UNITED STATES PATENT AND TRADEMARK OFFICE

| APPLICATION NO. | FILING DATE | FIRST NAMED INVENTOR | ATTORNEY DOCKET NO. | CONFIRMATION NO. |
|-----------------|-------------|----------------------|---------------------|------------------|
| 10/812,890 | 03/31/2004 | Robert Japp | EI-2-04-003 | 5018 |

| Office Action Summary | Application No. 10/812,890 | Applicant(s) JAPP ET AL. | |

DETAILED OFFICE ACTION

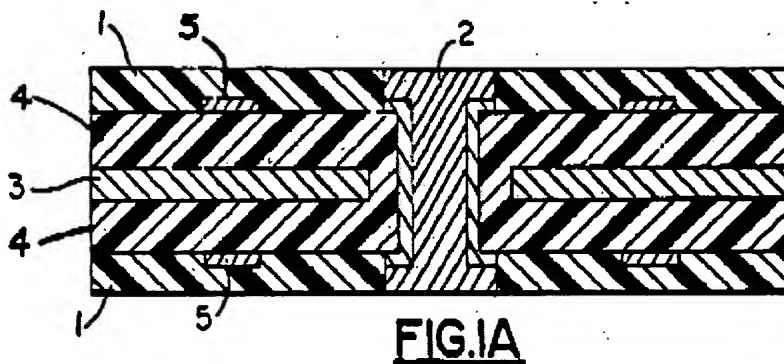
Bindra (fig 1A,the title, the abstract, column 2 line 13-25) discloses a circuitized substrate comprising: a first layer (fig 1 A, layer 4) comprised of a dielectric material including a resin material including a predetermined quantity of particles therein and not including continuous fibers, semi-continuous fibers or the like as part thereof; and at least one circuitized layer (layer 1 ,circuit 5 fig 1A) positioned on the first layer.

Noted that Bindra uses PTFE and CTFE organic resin compound with quartz or silicon particle filler and therefore, the dielectric does not contain fibers.

FIG. 1

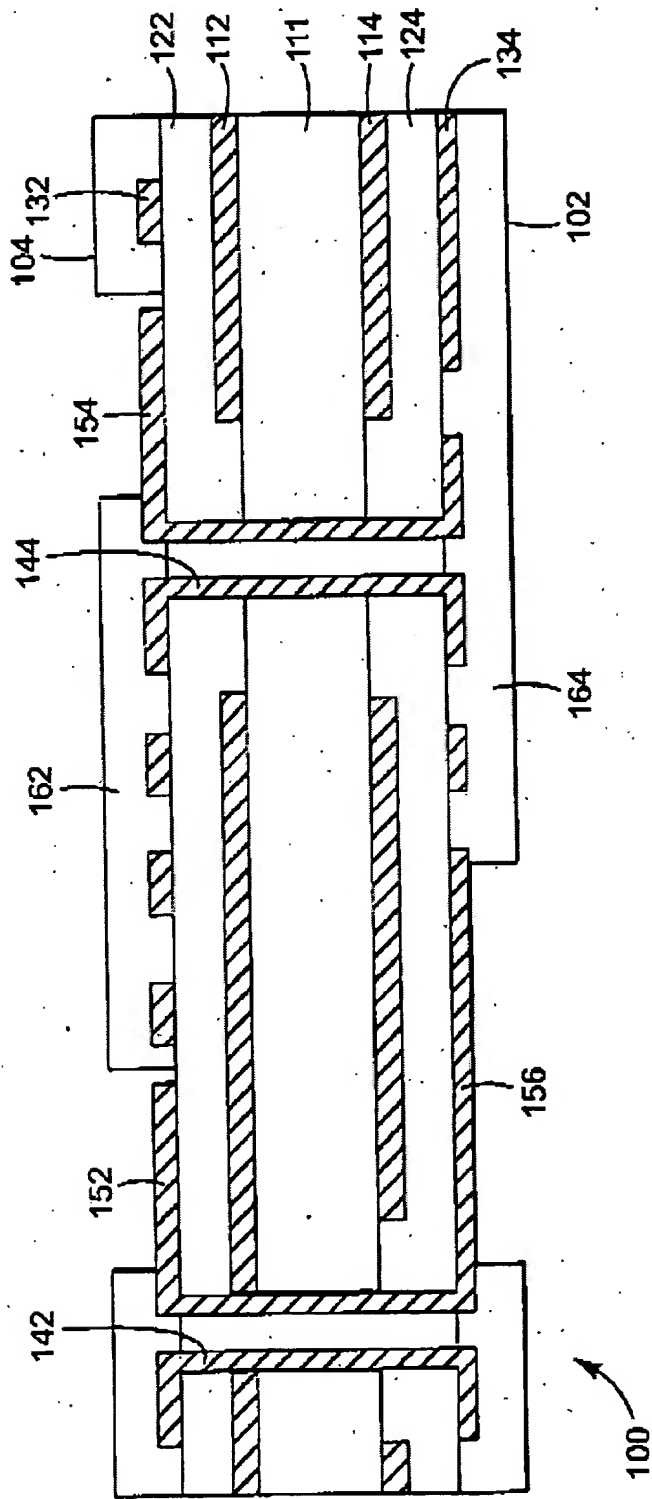
Mao discloses (in fig 1 in paragraph [0013]) a circuitized substrate comprising: a first layer comprised of a dielectric material including a resin material including a predetermined quantity of particles therein and not including continuous fibers, semi-continuous fibers or the like as part thereof; and at least one circuitized layer positioned on the first layer this circuitized substrate further including second and third dielectric layers positioned on the at least one

circuitized layer and the second circuitized layer, respectively, and third and fourth circuitized layers formed on the second and third dielectric layer, respectively.

Noted that Mao discloses a circuitized substrate that has 3 dielectric layers with layers 124, 111 and 122 correspond to the first, second, and third dielectric layers and layers 134, 114, 112, and 132 correspond to the first, second, third, and fourth circuitized layers.

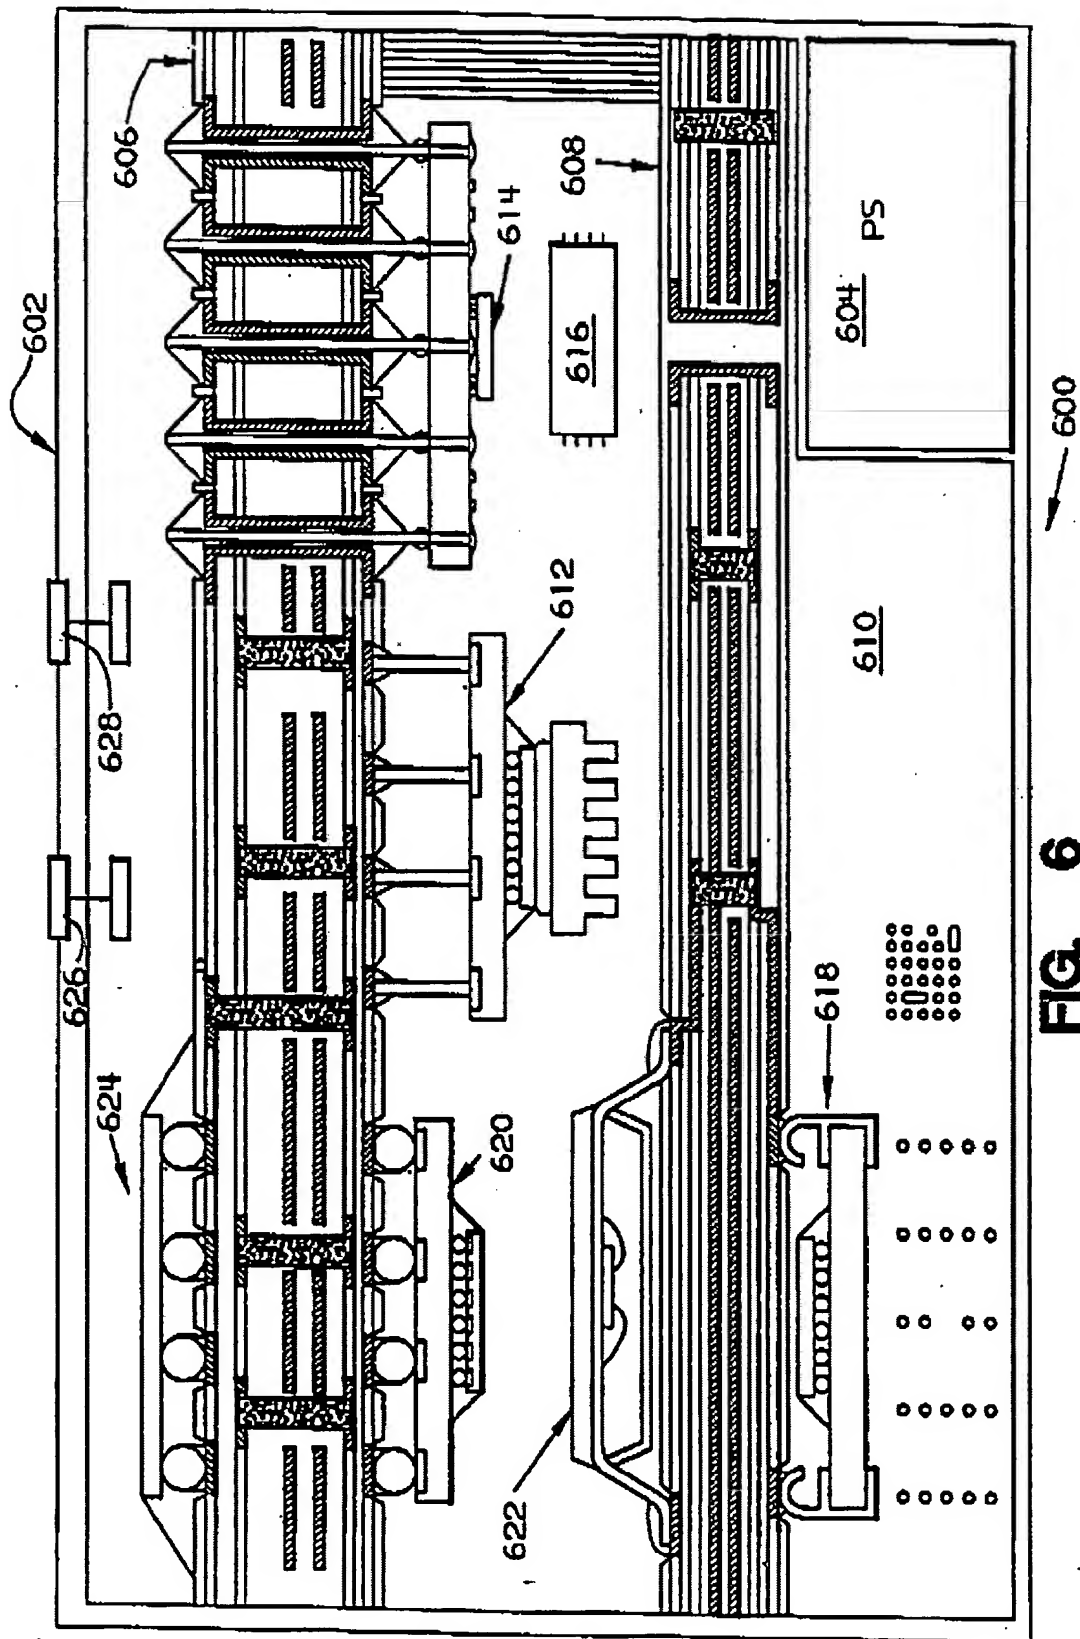
Bindra (fig 1A) discloses all the invention except for the relative size of the through holes in respect with the thickness of the substrate, the size of the filler particles and the percent of the content of the particles filler for the substrate. These limitations, however, are considered obvious since it has been held that when the general conditions of a claim is disclosed in the prior art discovering the optimum value or workable range is within the ordinary routine skill of an ordinary artisan in the art.

A person skilled in the art at the time the invention was made would be able to derive from the teachings by Bindra and his own routine design skill and come up with the inventions of claim 2,4,10 for the purpose of improving the device invented by Bindra.
